# HISTORIC AND DESIGN REVIEW COMMISSION

December 20, 2023

**HDRC CASE NO:** 2023-478  
**COMMON NAME:** 1304 E HOUSTON ST  
**LEGAL DESCRIPTION:** NCB 574 BLK B-13 LOT 31 MERCHANTS SUBD  
**ZONING:** D  
**CITY COUNCIL DIST.:** 2  
**APPLICANT:** Jeremy Jaramillo/TBA Douglas  
**OWNER:** Pat Kennedy Jr./TPB Merchants MM, LLC  
**TYPE OF WORK:** Construction of a 6-story parking structure  
**APPLICATION RECEIVED:** December 01, 2023  
**60-DAY REVIEW:** January 30, 2024  
**CASE MANAGER:** Edward Hall

The applicant is requesting a Certificate of Appropriateness for approval to construct a 6-level parking structure at 1304 E Houston Street. This property is located within the Downtown Design Guide area. The proposed new construction will be bounded to the north by E Houston, to the east and south by private property and to the west by Union Pacific railway tracks.

**MERCHANTS ICE GARAGE** | E. HOUSTON ST. FACADE

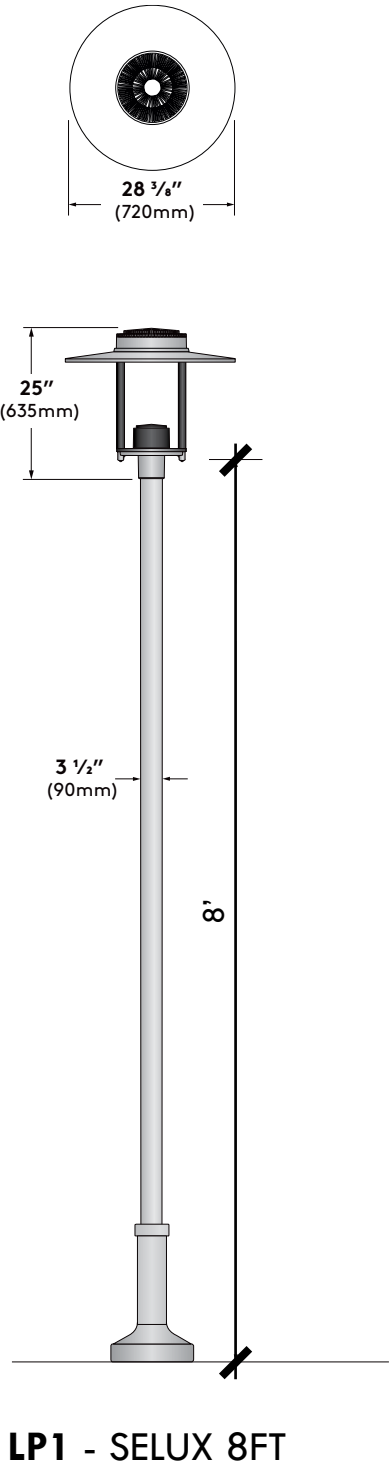
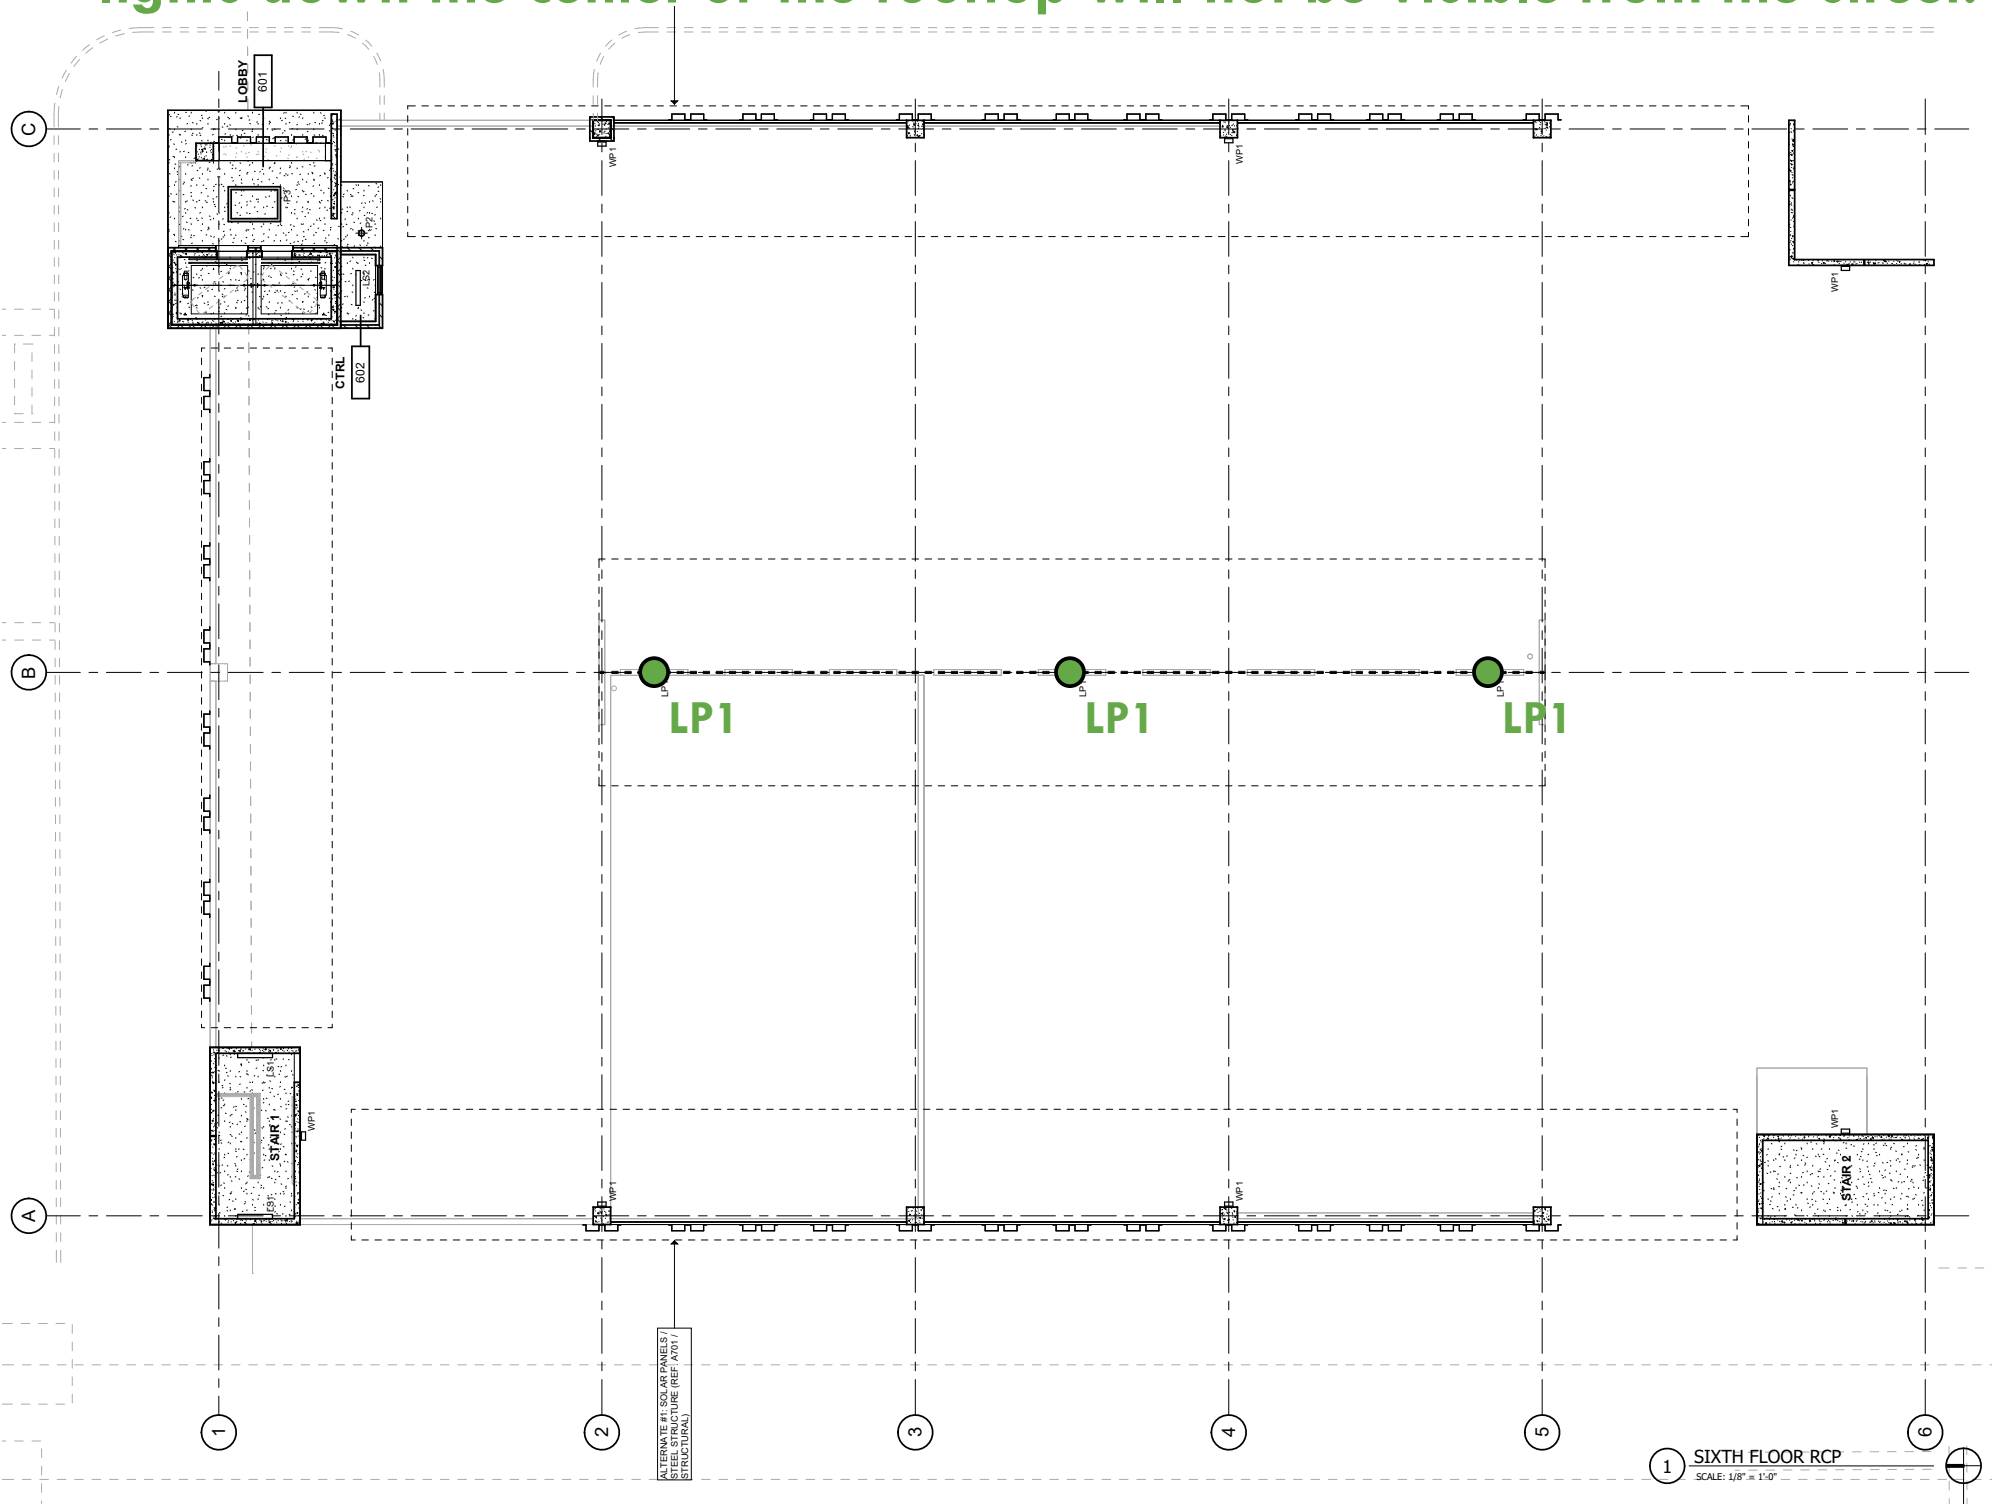
- i. That vertical facade elements be added the complete length of each facade.  
Refer to A201 and A202 for updated elevations. The south facade is designed to accomodate future expansion of the garage.

- i. That vertical facade elements be added the complete length of each facade.  
Refer to A201 and A202 for updated elevations. The south facade is designed to accomodate future expansion of the garage.

## PLANTING PLAN

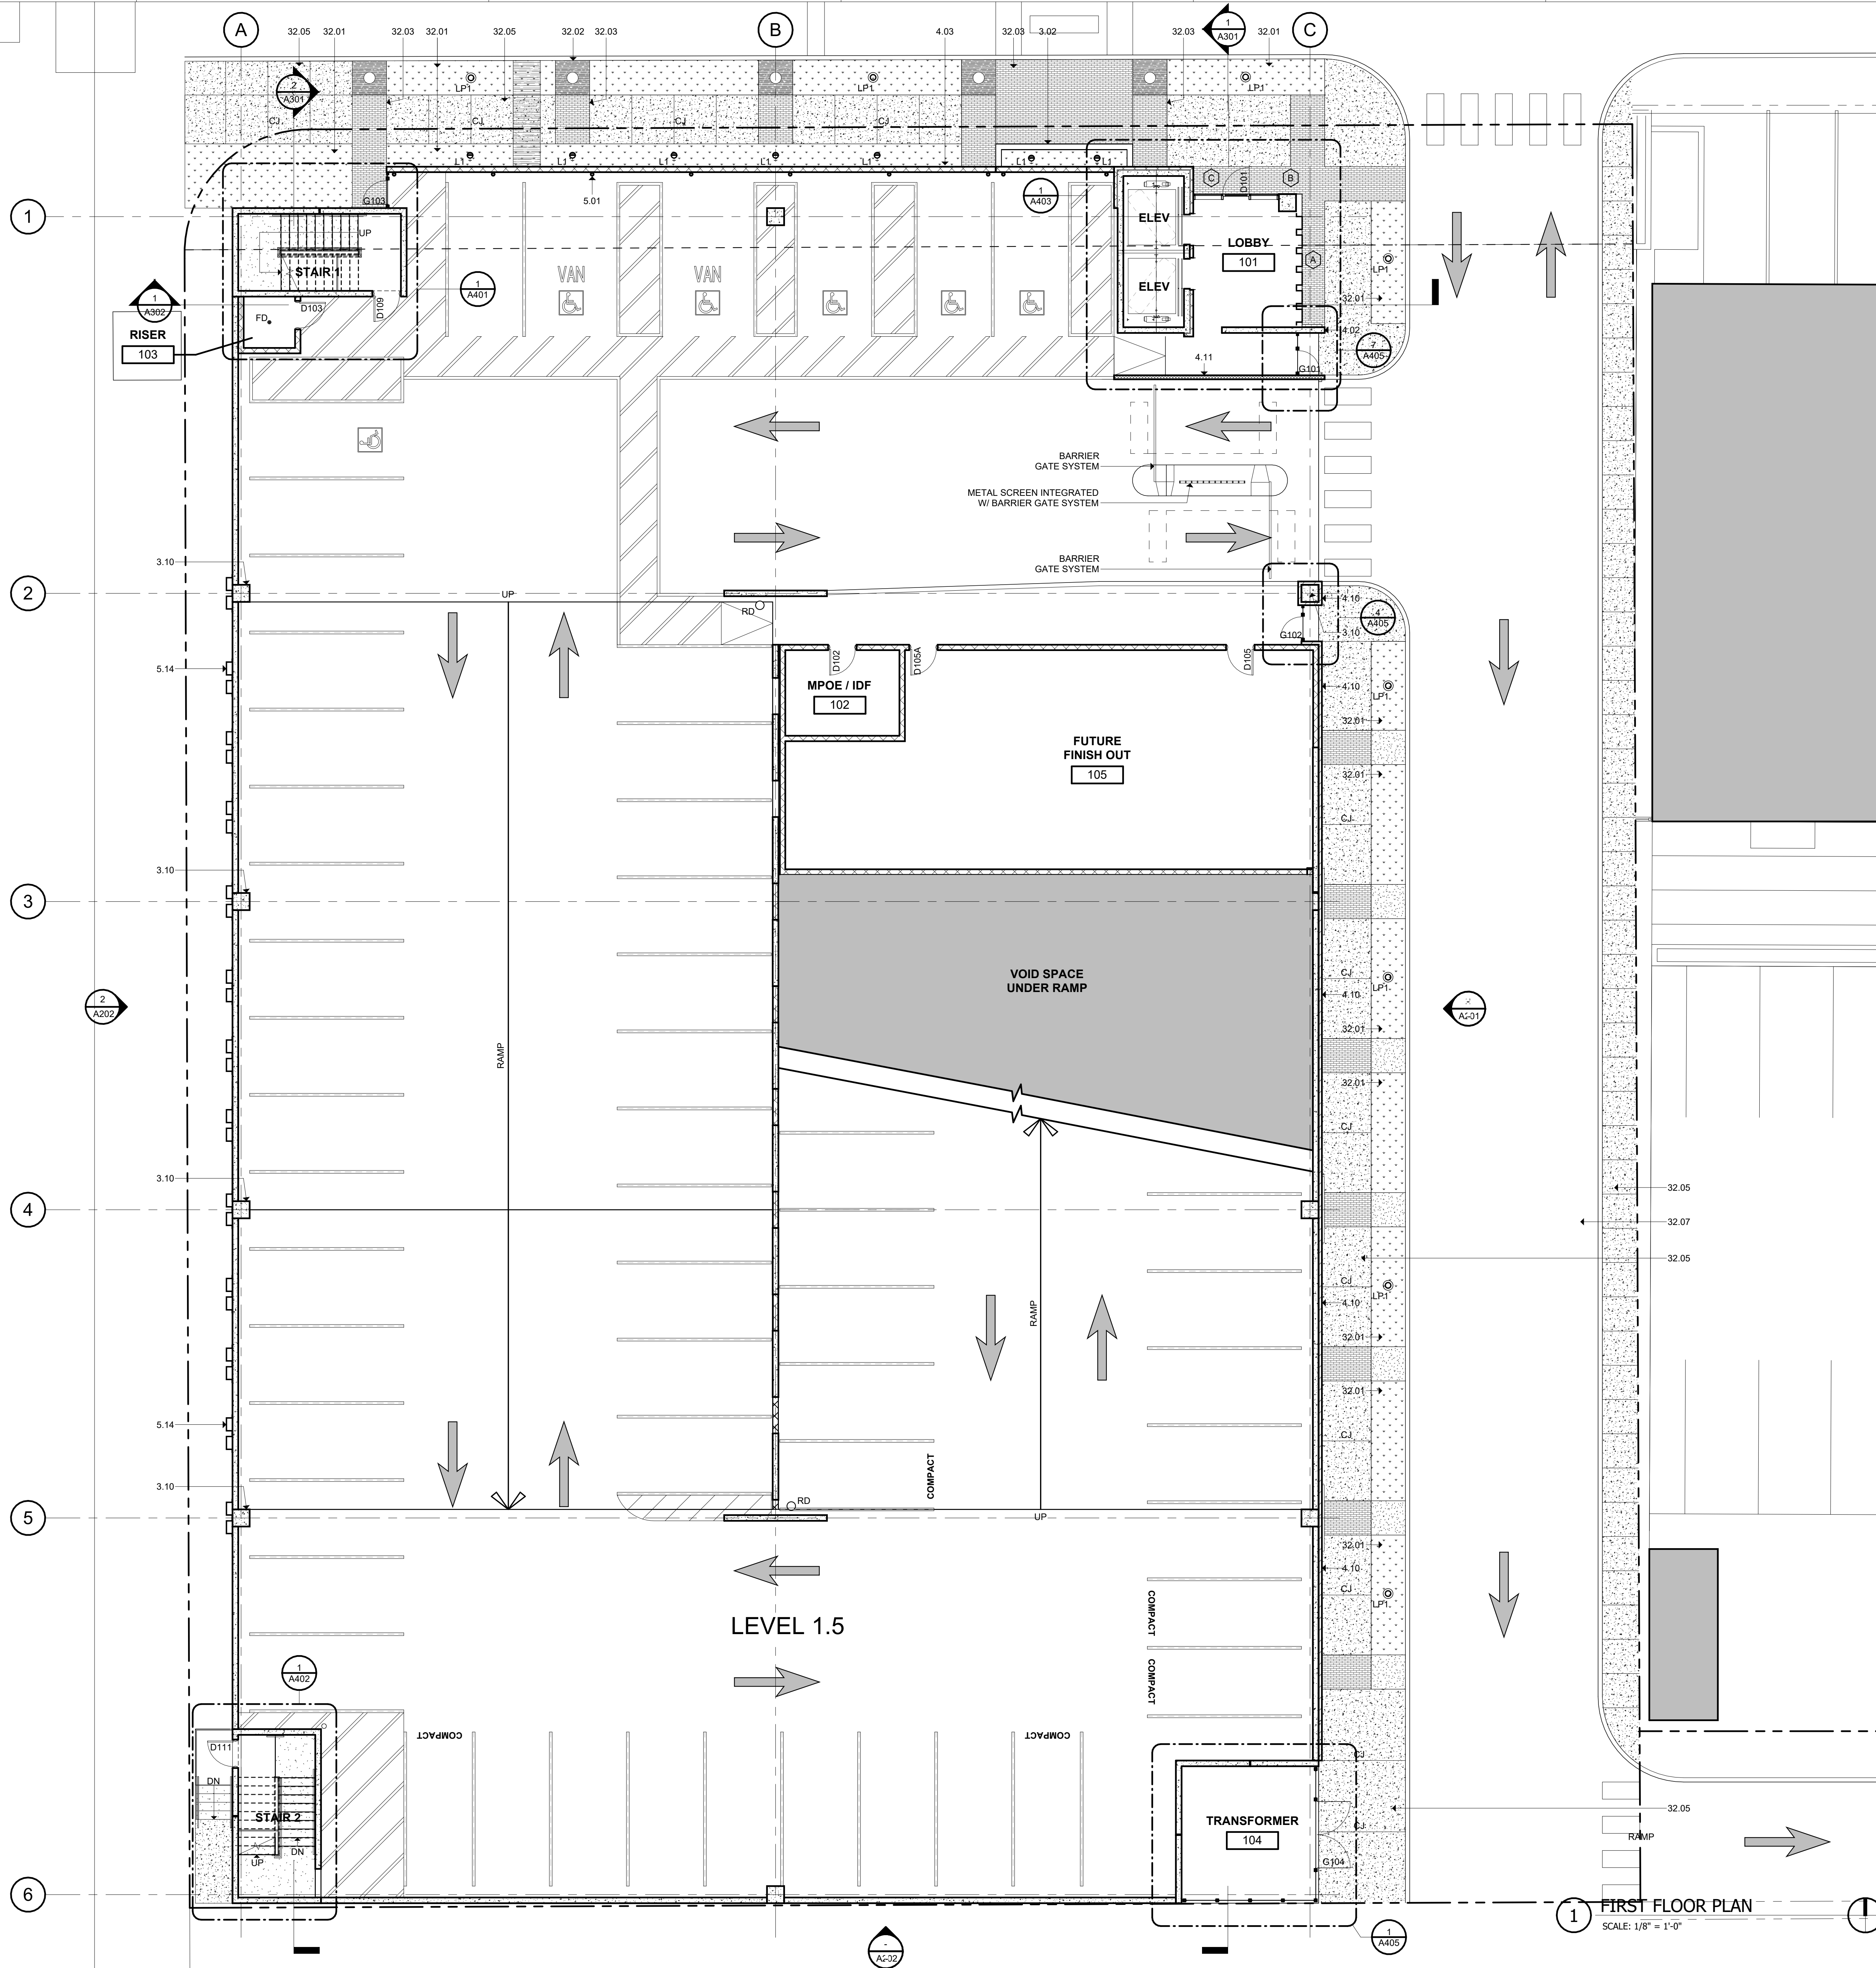
- v. That all landscaping elements adhere to the Downtown Design Guide. ***This stipulation has not been met.***
- c. DESIGN REVIEW COMMITTEE – This request was reviewed by the Design Review Committee on December 11, 2023. At that meeting Commissioners asked questions regarding façade screening elements, lighting, materials, and commented on updates to the design.

- v. That all landscaping elements adhere to the Downtown Design Guide.  
Refer to A100 and L4.01 for site and landscape plans and updated renderings below.
